See comments from  
engineering in blue

# PRELIMINARY/FINAL DRAINAGE REPORT FOR ROMENS SUBDIVISION

OCTOBER 2020

## Site-Level Low Impact Development (LID) Design Effective Impervious Calculator LID Credit by Impervious Reduction Factor (IRF) Method

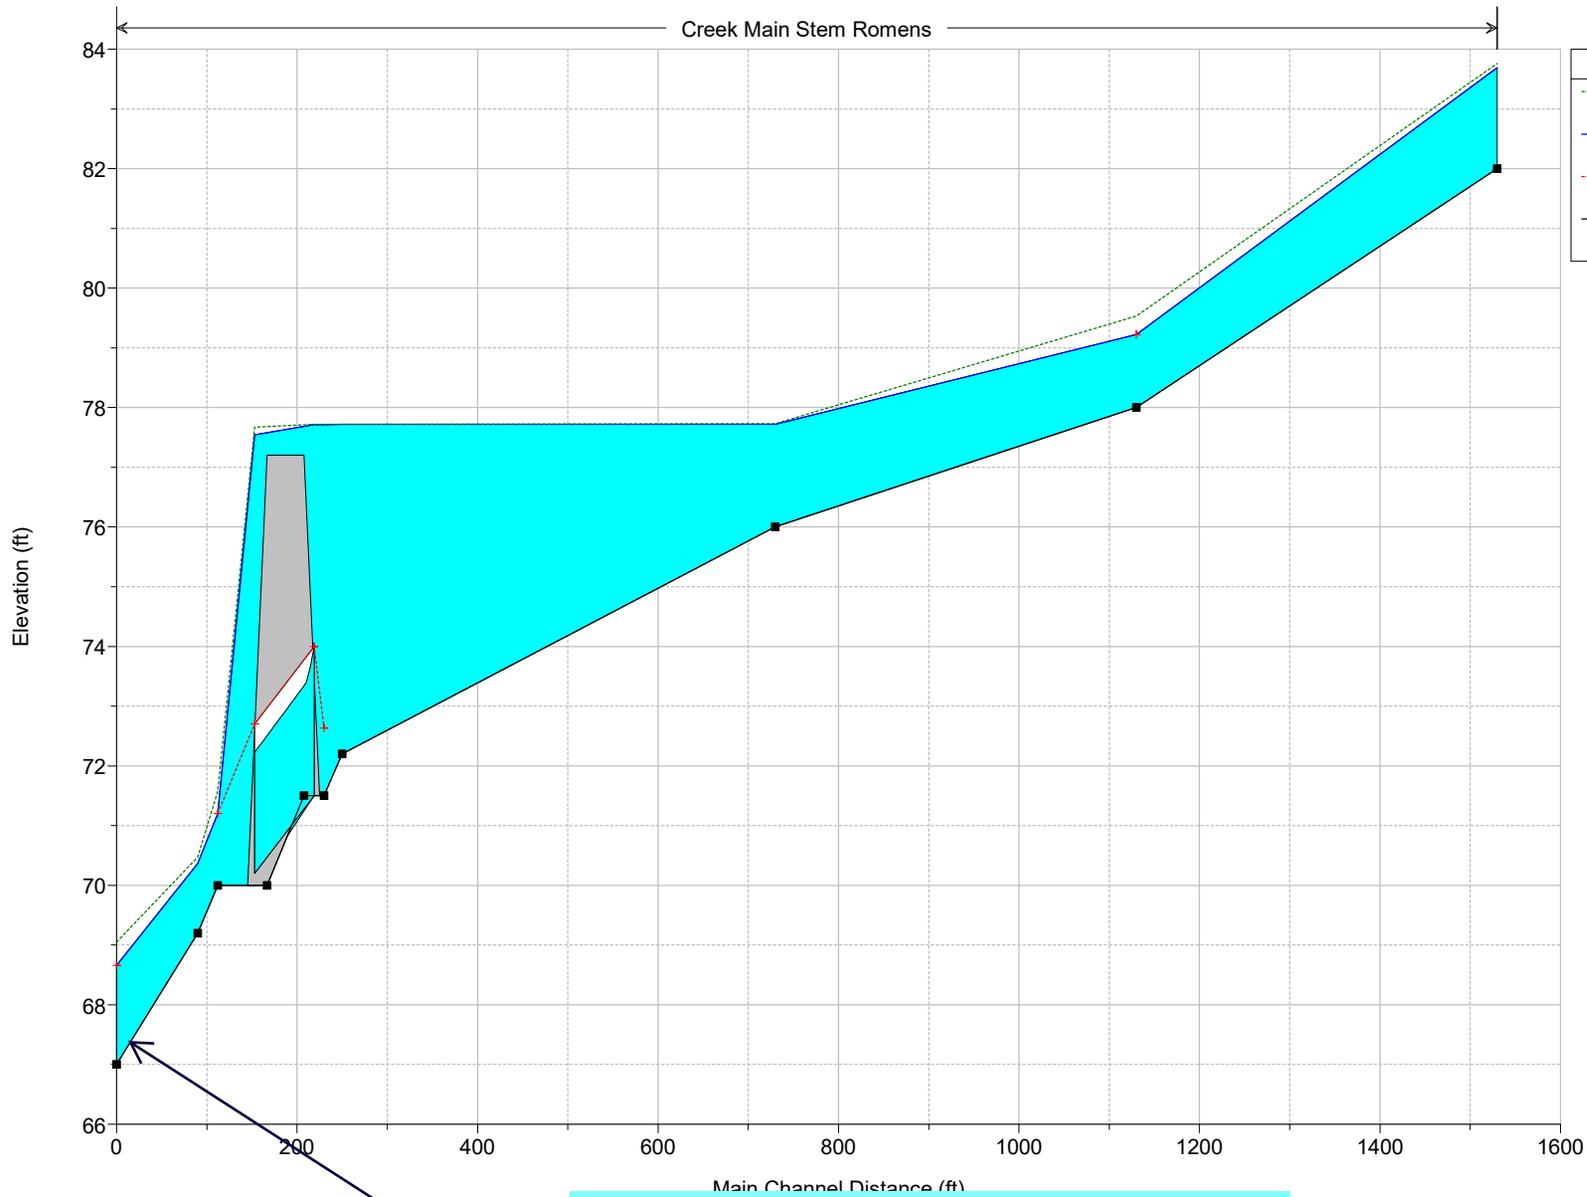
The narrative and the inputs do not match. The narrative mentions 1 acre of developed area which is significantly more than the inputs. Revise to use 7% per ECM appendix L.

HEC-RAS Plan: 96cfs River: Creek Main Stem Reach: Romens Profile: PF 1

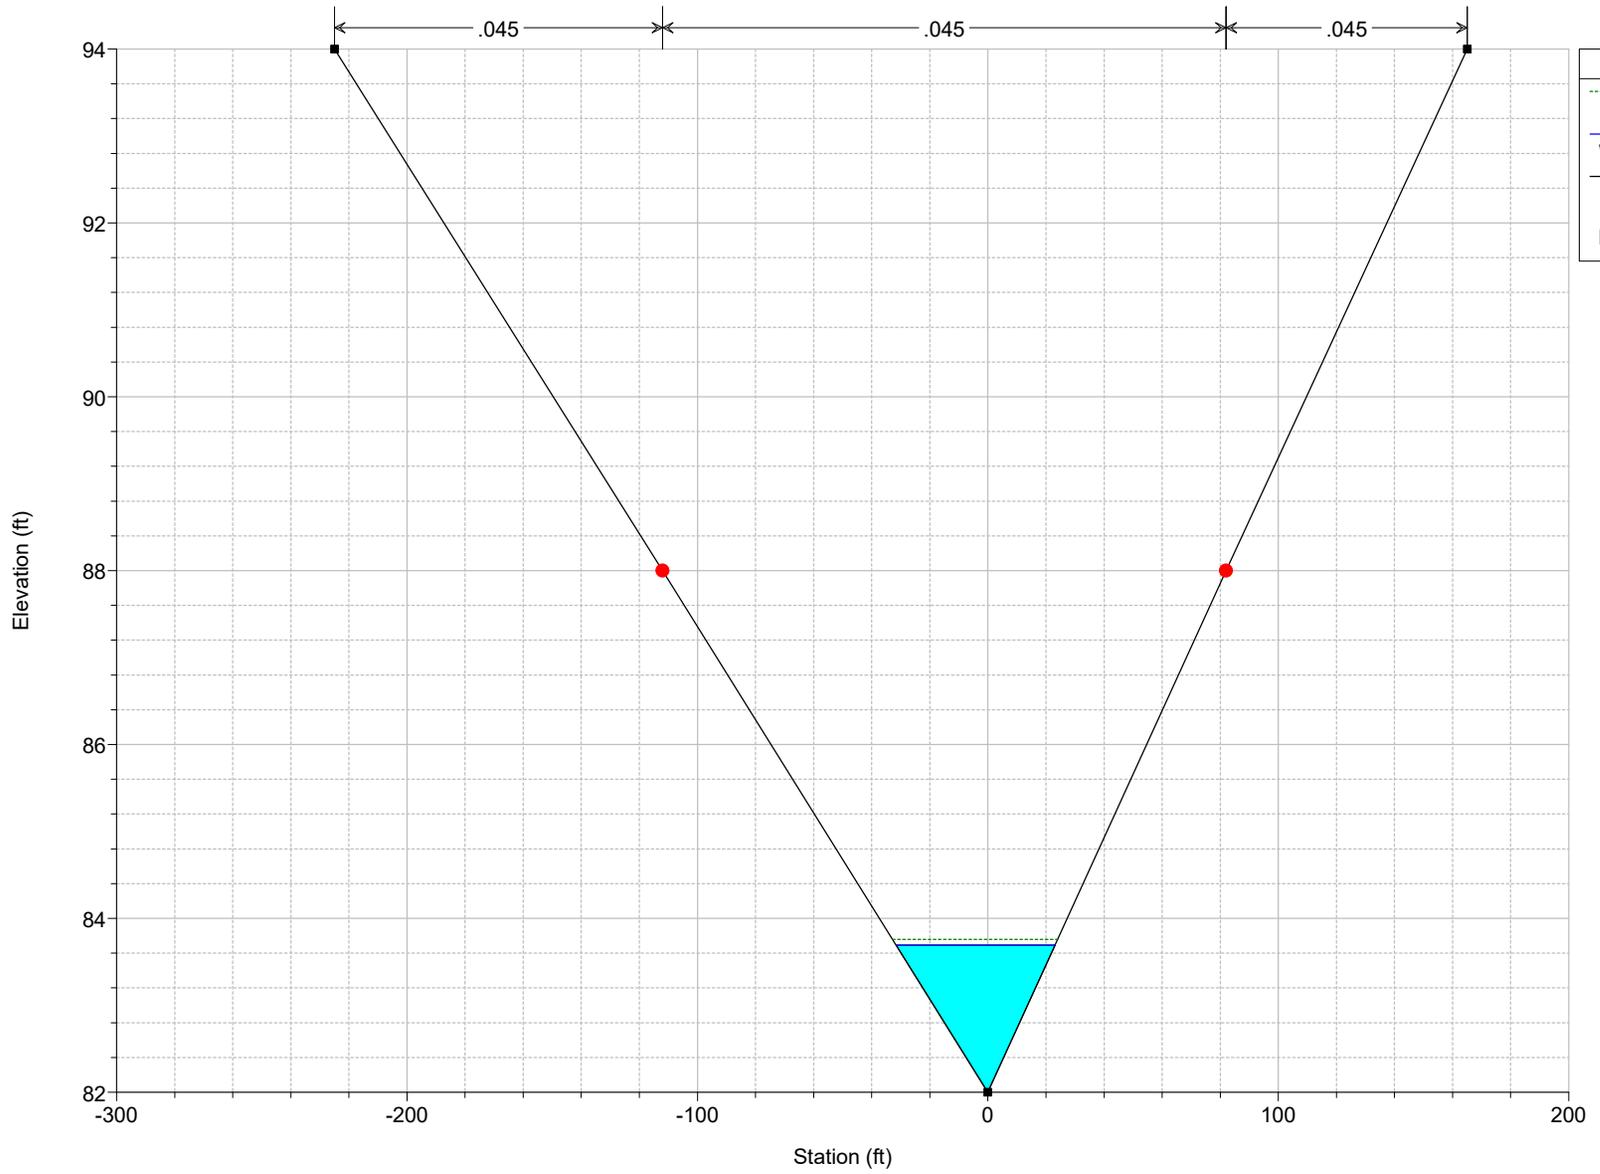
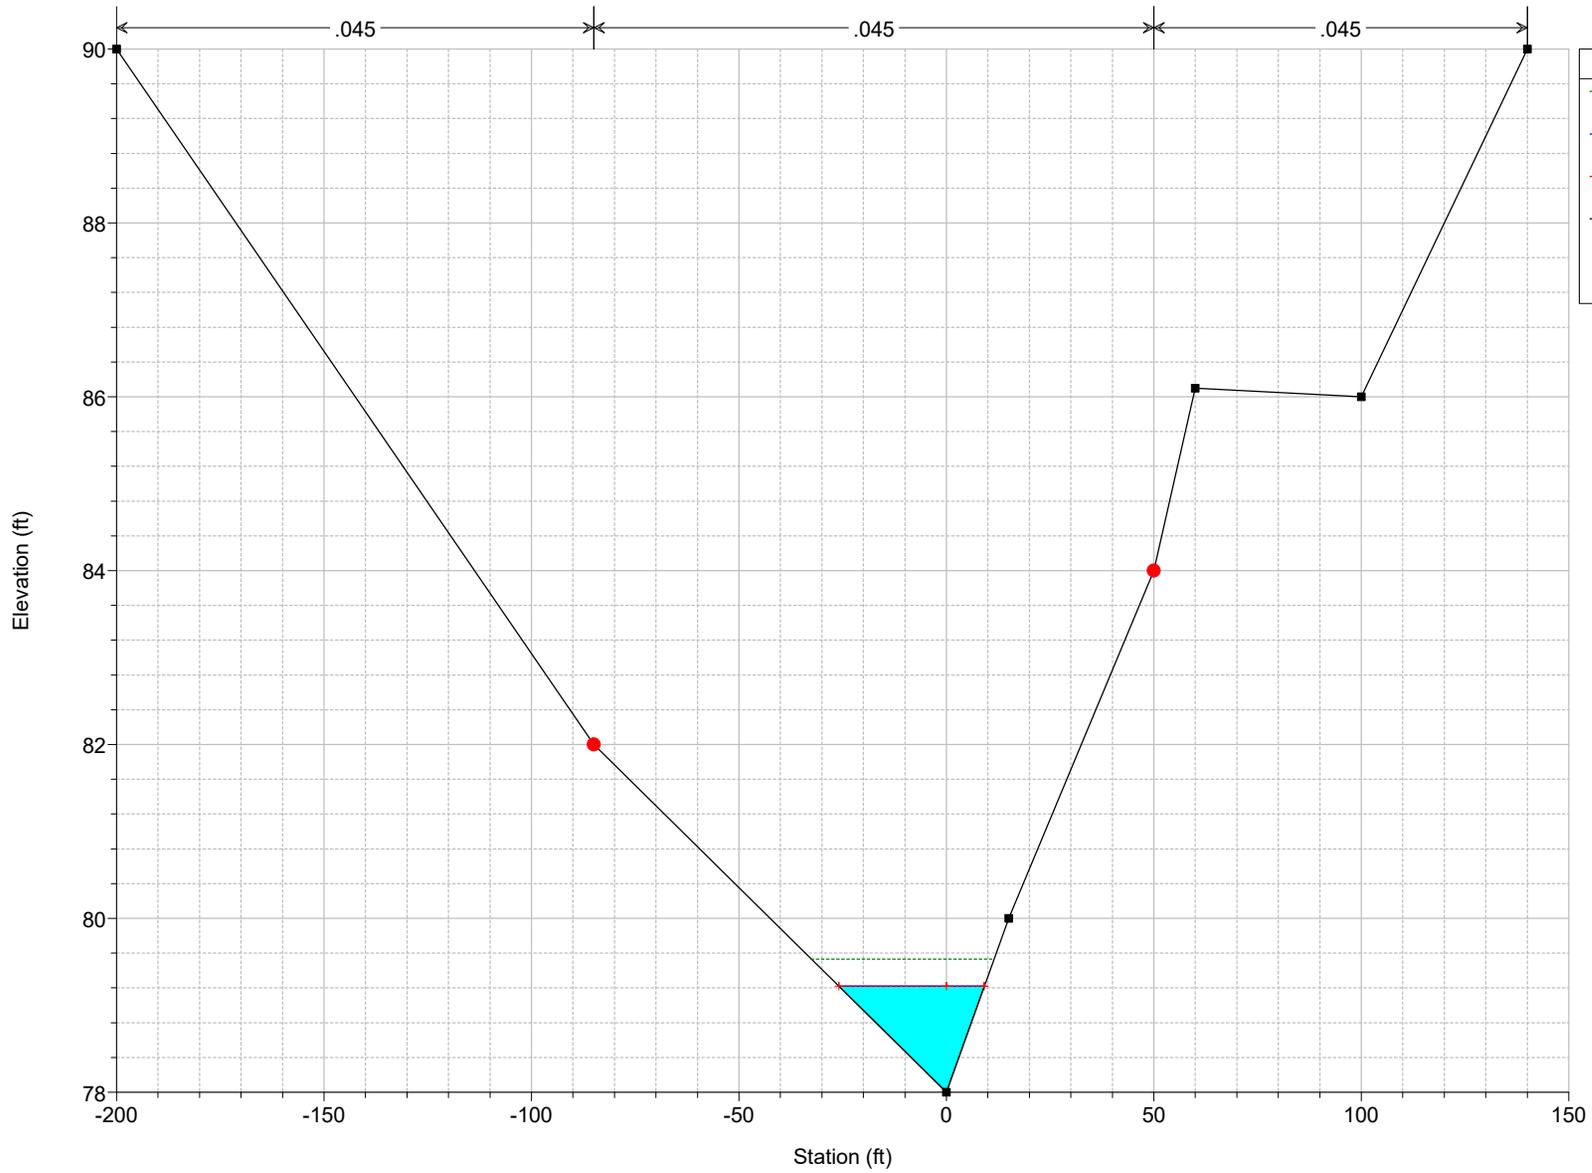
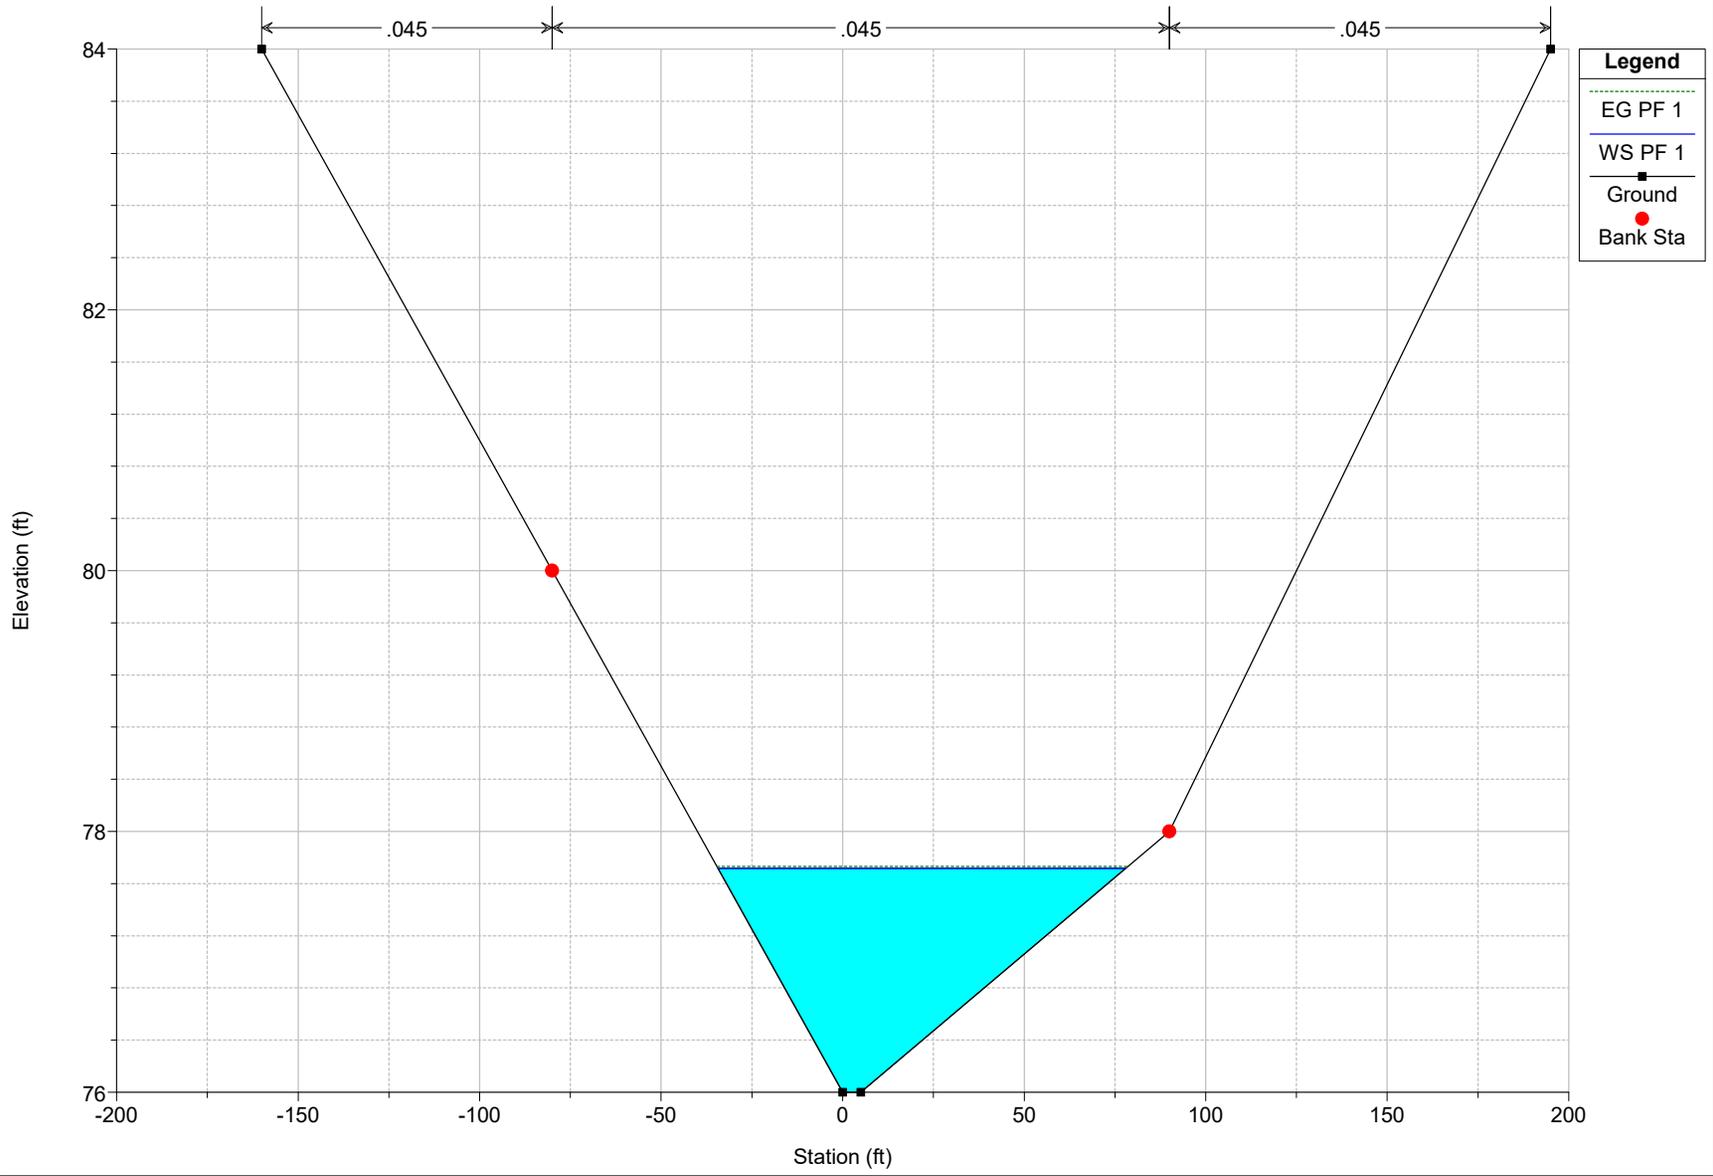
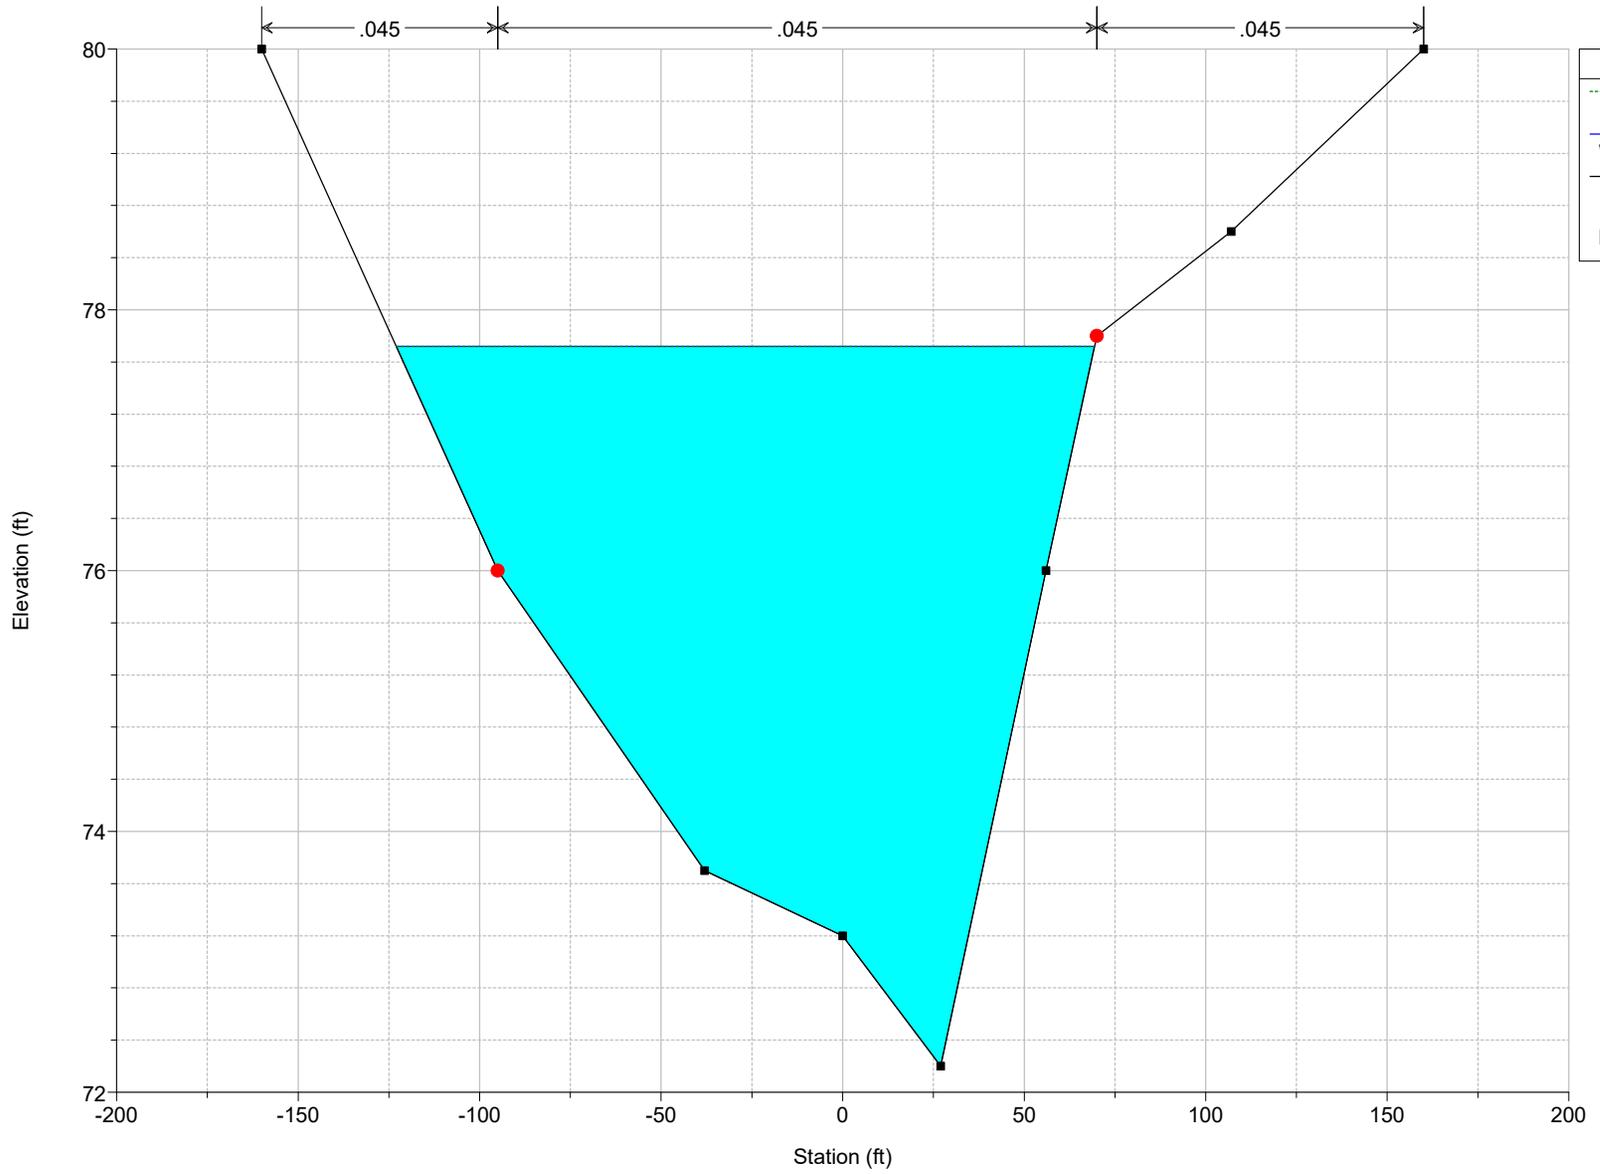
provide the downstream boundary condition used and describe in the narrative.

Provide the table for the other cross sections.

Provide label identify which cross section these are. Typ. All
